6.6 KV VACUUM CONTACTOR PROBLEM 'G' BLAST FURNACE

Record note of discussion and site Demo by Areva Engineers On HV contactor panel mechanical trip mechanism and trip coil burning problem. Date-16-12-05

AREVA solution for mech trip

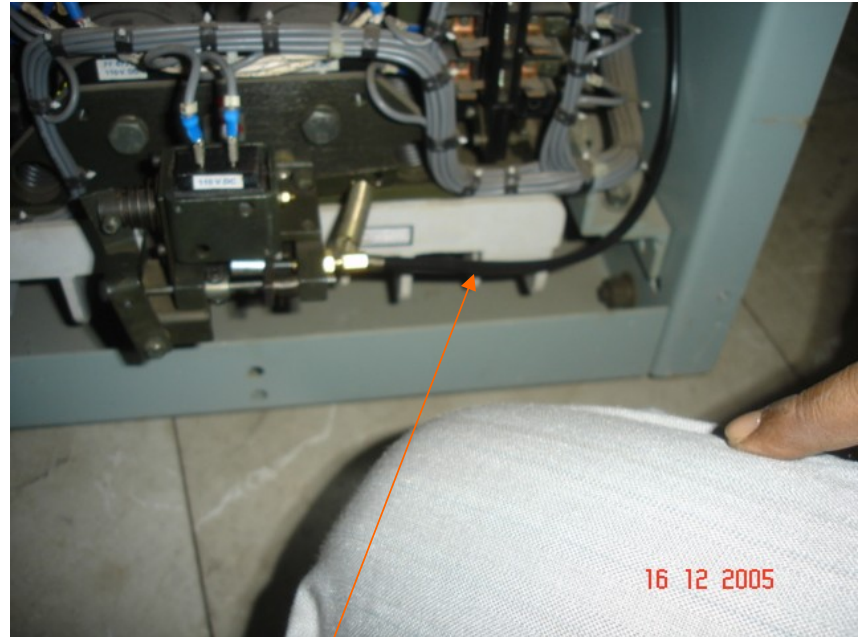
Round rod and grub screw

Coil 110 V DC

TATA steel didn't accept the arrangement since it was observed that slight loosening of clutch wire was not allowing the contactor to close, that means chattering of contactor taking place during switching on operation. It was proposed to provide oval cutout at the bottom with flap similar to the breaker-racking opening and loose operating handle (insulated) so that mechanical trip is possible from outside the breaker through the opening whenever required.

TATA steel pointed out that loosening of striker metal ring from its position was the main reason for not tripping the contactor and burning of trip coil. It was observed that the guide rod on which this metal ring is mounted is too thin (Approx. 3mm) and round, hence the striker ring got loosened due to vibration after several operation.

AREVA agreed to make necessary modification with permanent locking mechanism so that it does not loose after repeated operation.

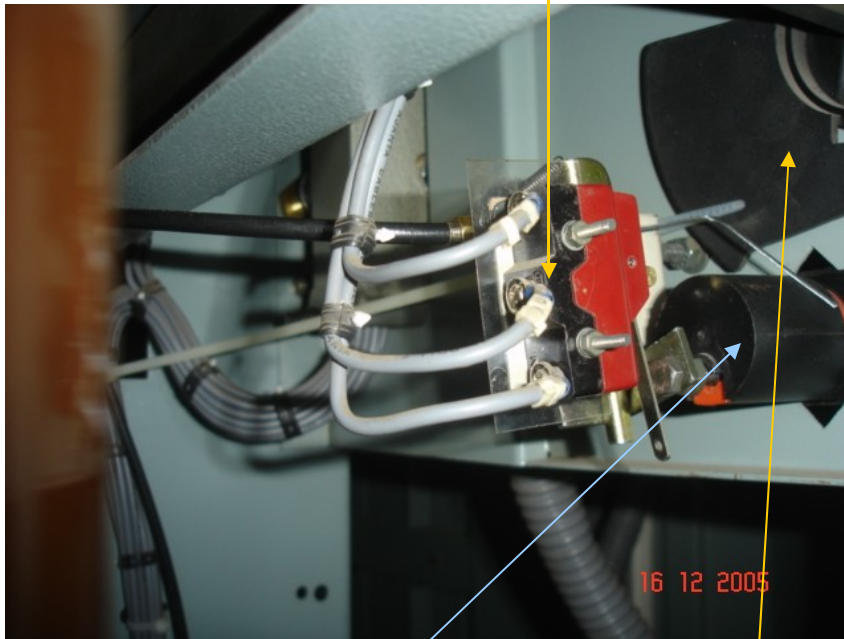
Electrical s/w available instead of mechanical trip mechanism.

Trip actuator

Lock/Free s/w for VC in/out should trip VC mechanically (Standard safety Features)
